### **Re: Rivendell Feedlot DA103 - 2021**

Council forwarded a request for additional information on the 30<sup>th</sup> of December 2021 in relation to the traffic impact assessment and concerns raised by Essential Energy.

SCALES : HORIZ 1 in 100 (A4) VERT _____ DATUM : _____ SURVEYED : JBARR DESIGNED : JBARR CHECKED : P. TAYLOR	<b>S.M.K. CONSULTANTS</b> surveying - irrigation - environmental PO BOX 774 MOREE 2400 PHONE (02) 67 521021	CLIENT : NA & ML Jamieson PROJECT : Rivendell Feedlot 2000 Head	DESCRIPTION : Power Pole Fencing Layout Plan

Appendix 1: Sketch plan showing proposal for Power Pole protection within feedlot pen

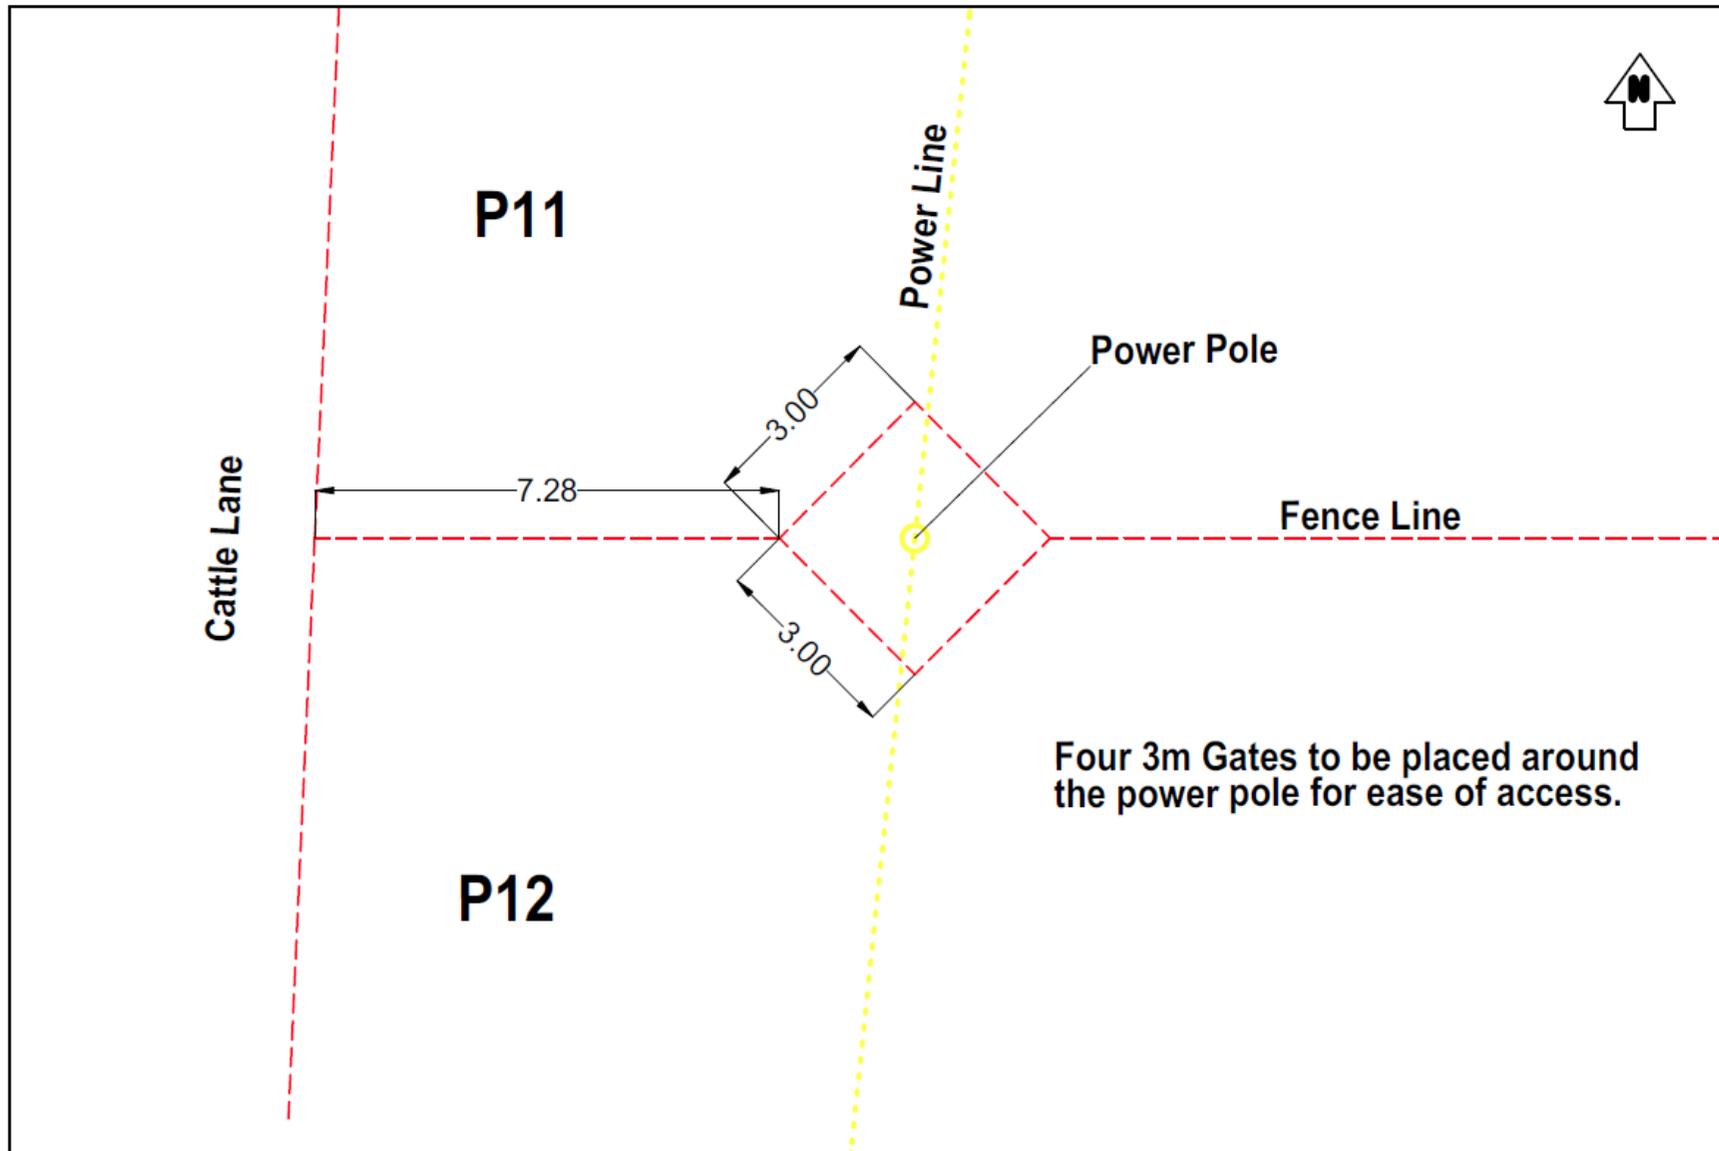
To protect the power pole and provide complete access to the pole for repair or maintenance work, the new fencing will include establishment of a protective fence around this pole. The fence will consist of four by 3m wide gates. The gates can be opened to allow free access to the power pole and the posts holding the gates will also be removal if required. Appendix 1 presents a sketch of the proposal.

In relation to 5m clearance around the one power pole within the feedlot pens, the proposal allows for a 3m wide gate system to protect the pole from cattle. The gates and fencing can be completely removed in a brief period to enable open access by larger service trucks if required. Under such conditions, cattle would be removed from the adjoining pens to provide uninhibited access.
